ADDENDUM NO. 2.0

Project: Project #: 0520-464

Hiram Johnson HS Telecenter Upgrade Project

AD 2.13:

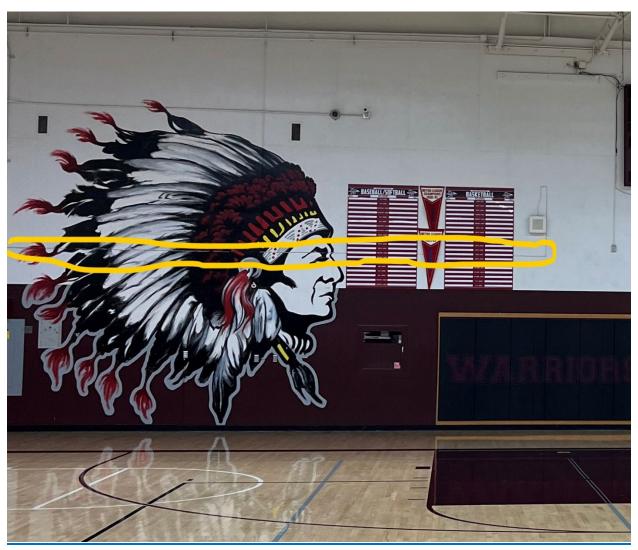
Question: There is a Mural in the Gym with existing cabling to be demo'd going across it that is painted to fit the mural. Who is responsible for painting the stripe left by removing the cable across the mural?

The contractor should clip the wire where loose from the wall and leave it attached to the wall where the mural is.
